<b>ADDENDUM NO. :</b>	<b>Four (4)</b>
<b>BID DUE TIME AND DATE:</b>	2:00 p.m., April 30, 2019 <b>(No Change)</b>
<b>BIDDER QUESTIONS BY:</b>	11:59 a.m., April 23, 2019
<b>LAST ADDENDUM ISSUED:</b>	11:59 p.m., April 25, 2019

**THE PURPOSE FOR THIS ADDENDUM IS:**

- **To provide a response to questions raised by Plan Holders;**
- **To modify/clarify specifications and drawings.**

SCALE: 3" = 1'-0"

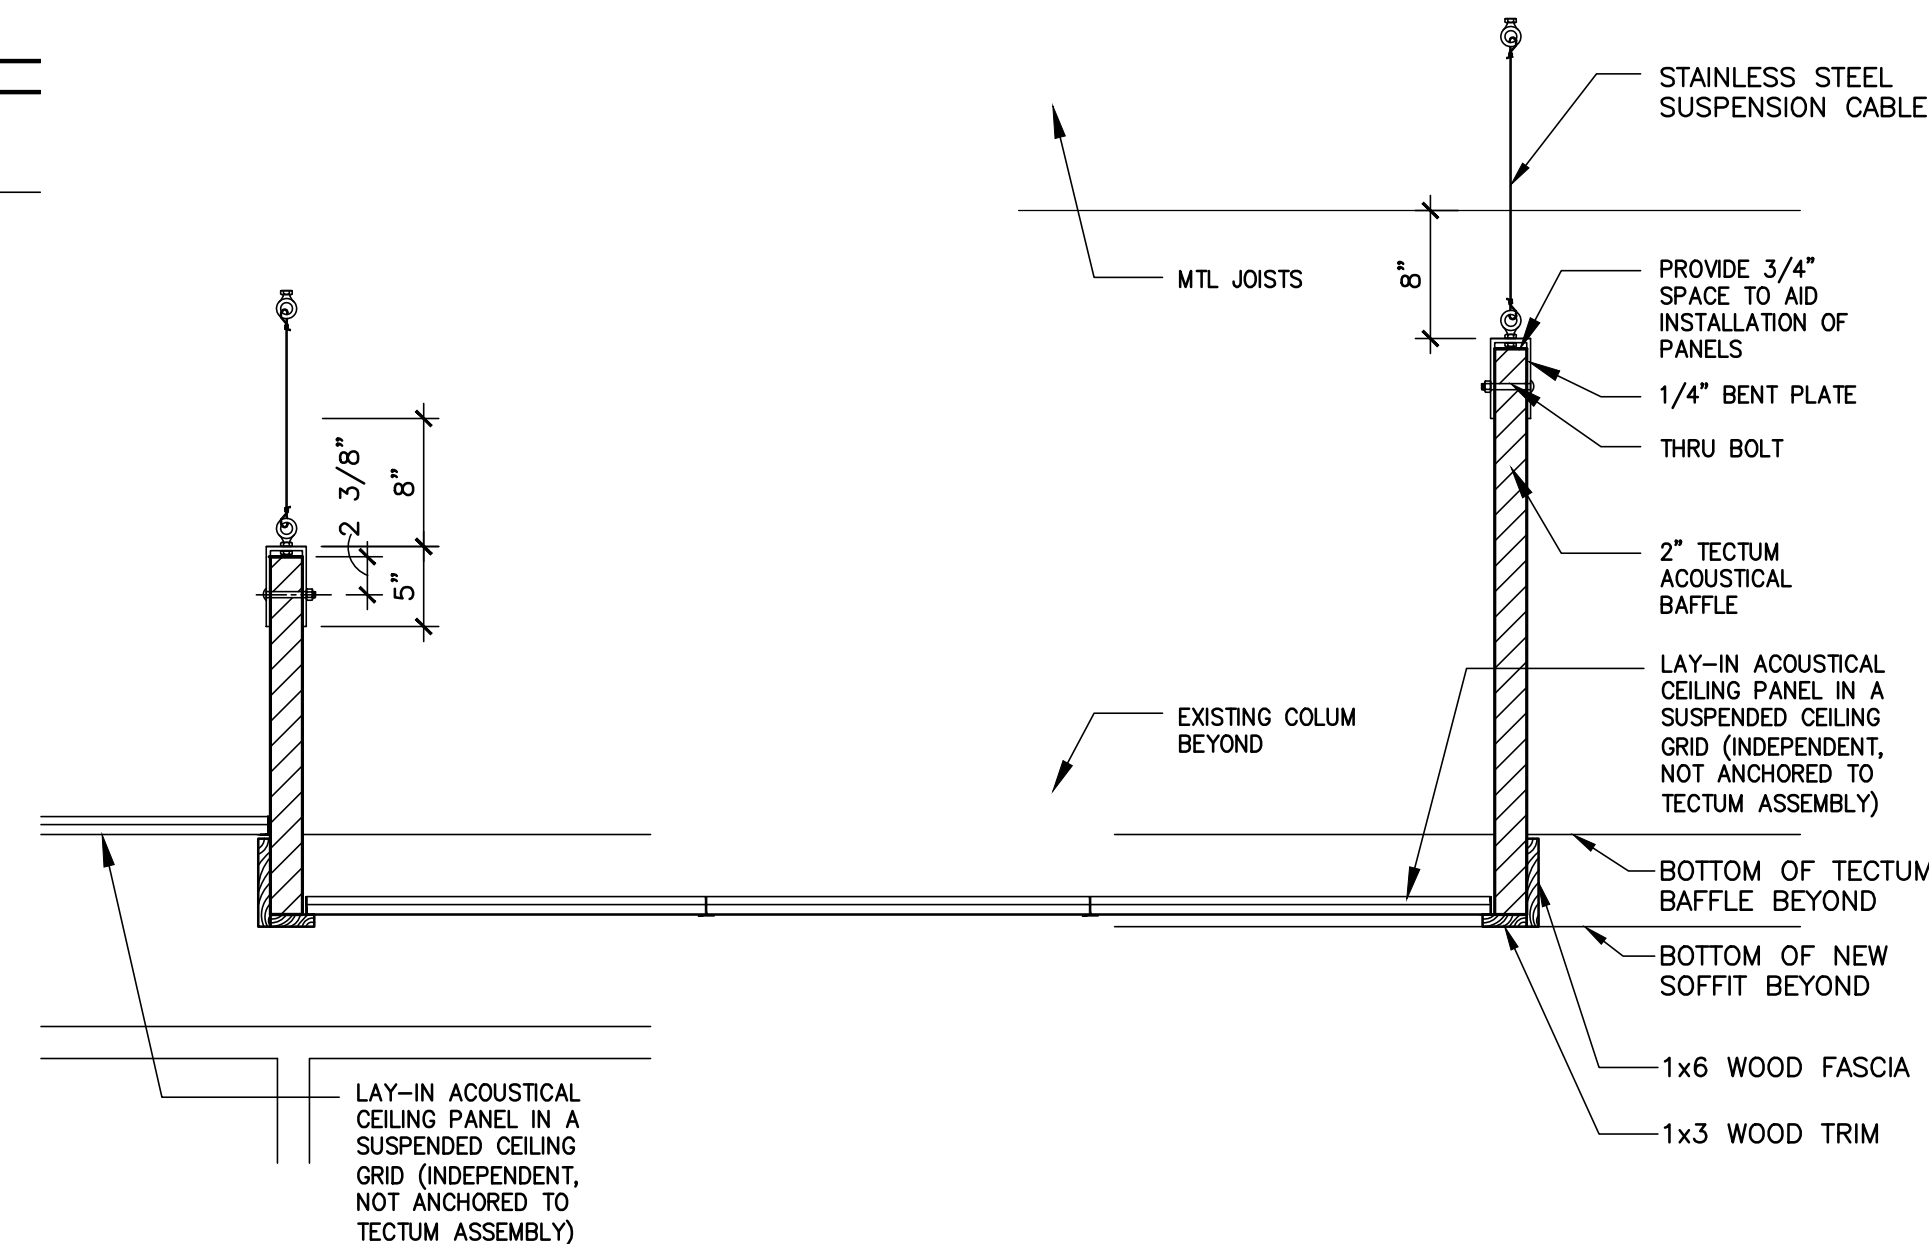
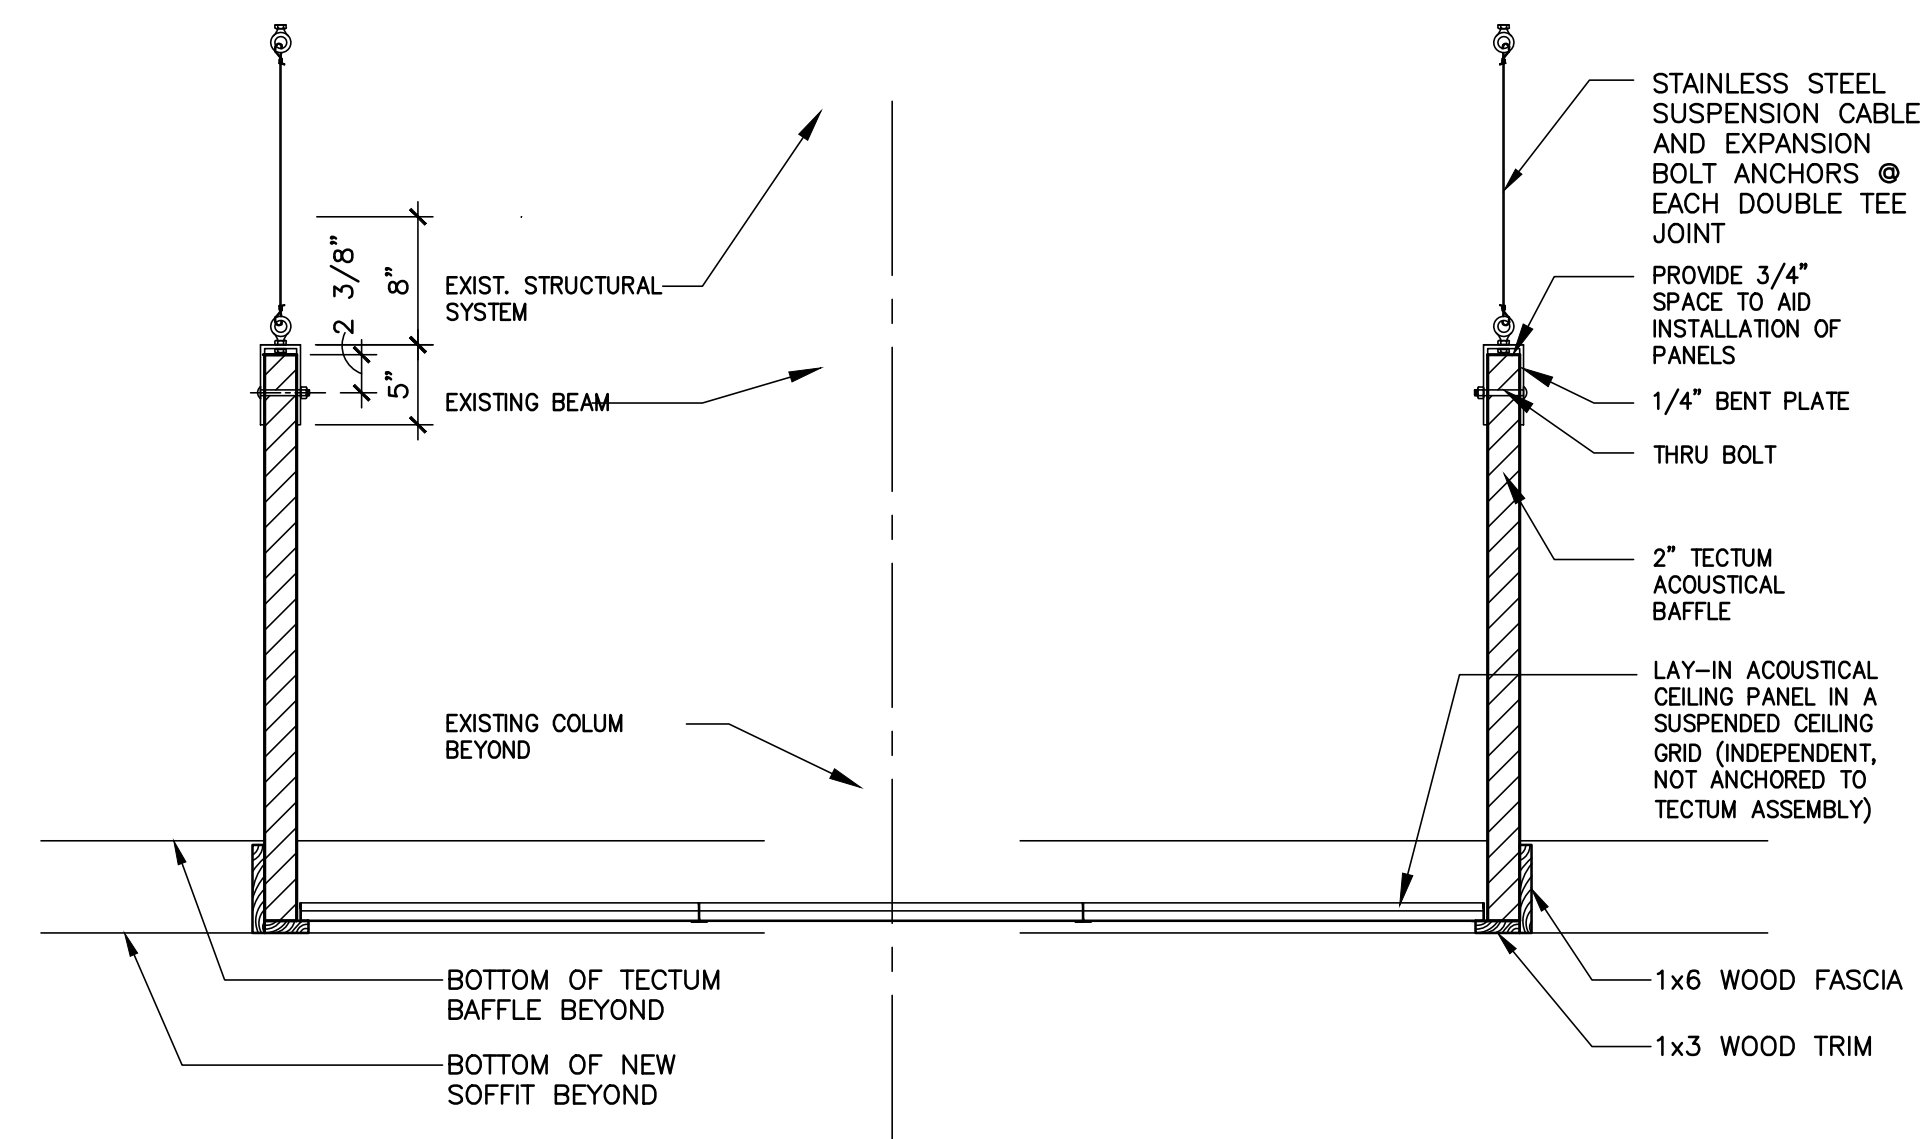
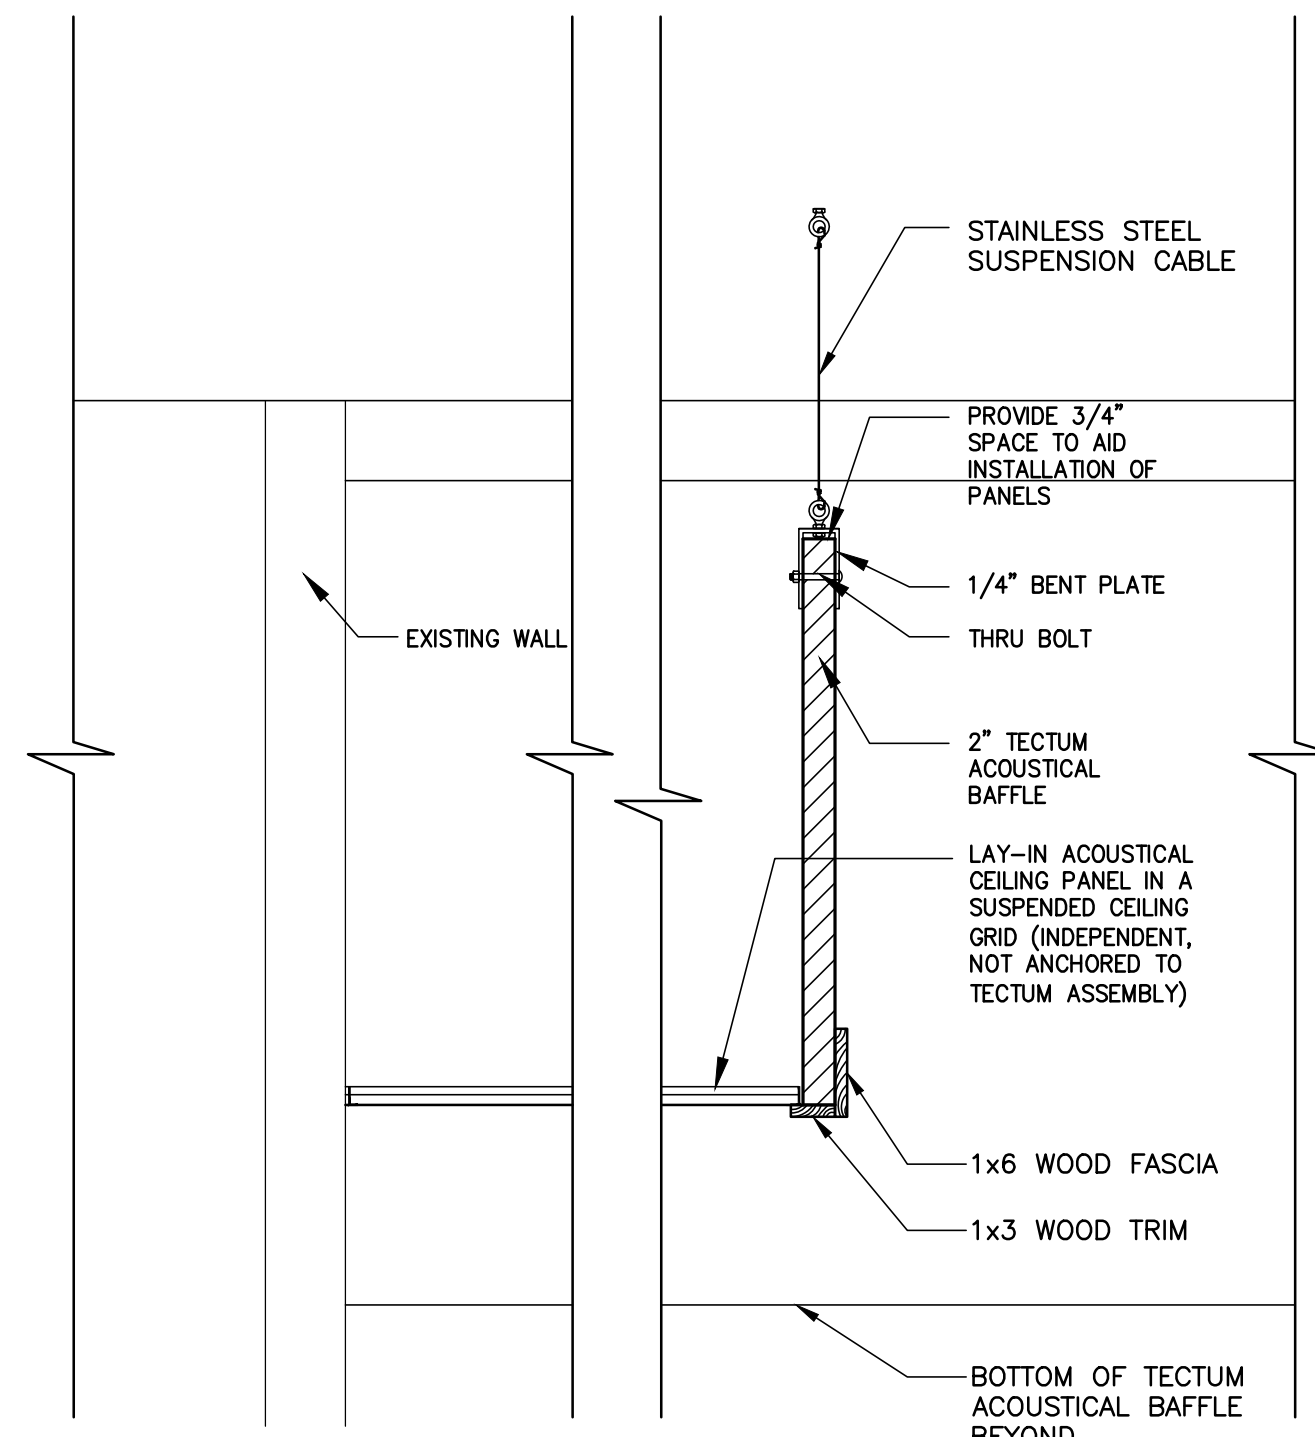
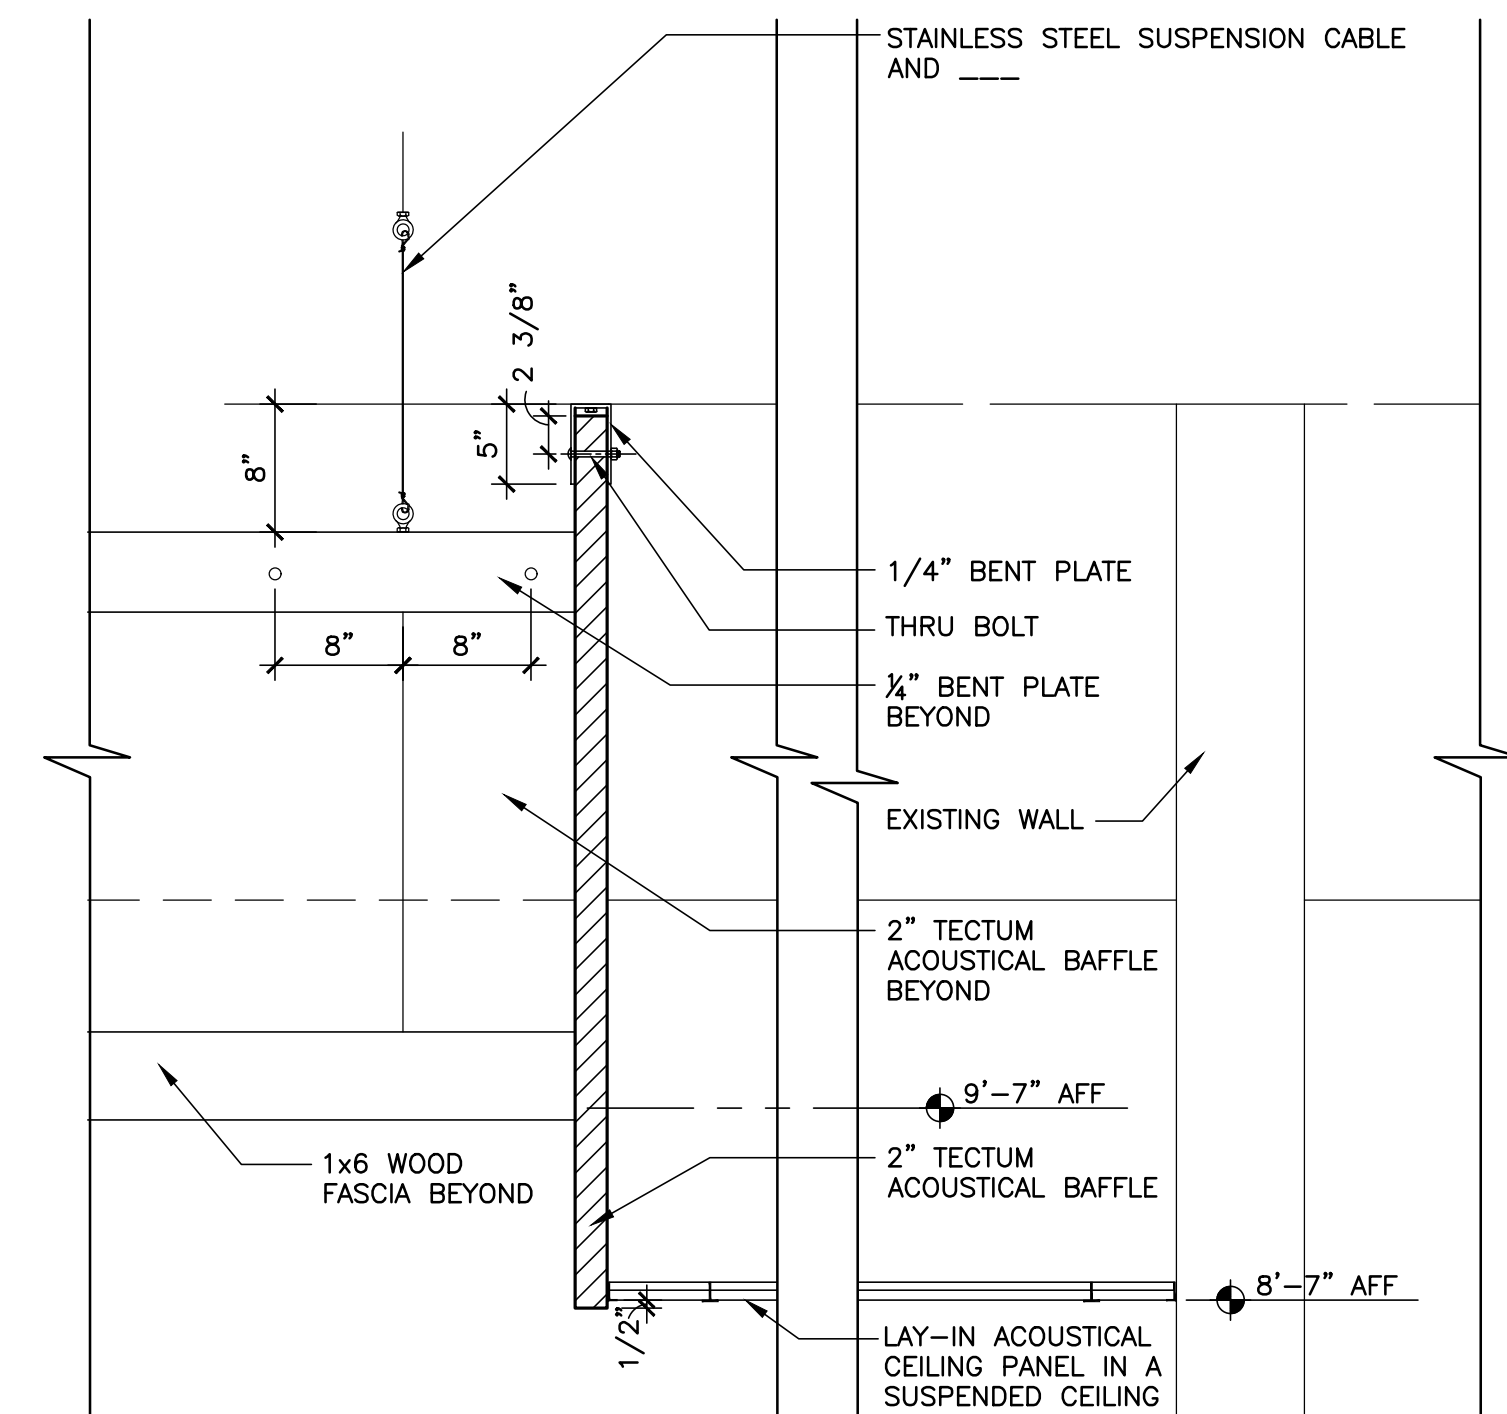
- Clarification on the wall types (section on acoustical separation, 2 hr, and detail at top of 10' wall) and ceiling cloud detail(s) and finish details such intent of columns for exposed electrical on CMU
- HVAC details such as air handler coil connection (what's needed re isolation valves, strainers, etc.)
- Extent of chilled water line treatment
- Specs/detail on OA louver to be installed within storefront (shown on HVAC, visible on Section A301, not A202 or A602)
- Redundancy on, and revisions to a few Hardware items; see hardware Spec sections attached.
- Sections clarified to indicate sill pan, as well as location of drainage barrier; all sections at stucco clarified to show weep at base of drainage plane. Additionally, simplify cast sills.

- A301 Building Sections
- A302 Building Sections
- A303 Ext Wall Sections & Details
- A304 Ext Wall Sections & Details
- A306 Ext Wall Sections & Details
- A502 Ceiling Details
- A601 Finish Schedule w/ Details
- P101, Updated plan to show missing fixtures and missing sanitary and vent piping
- P102, Updated plan to show missing fixtures, missing domestic water piping and missing gas piping
- P101, Updated plan to show missing fixtures and missing sanitary and vent piping
- P201, Updated plan to show missing fixtures and missing sanitary and vent piping
- P202, Updated plan to show missing fixtures, domestic water piping and missing gas piping
- M401, Added detail for chilled water connections to AHU
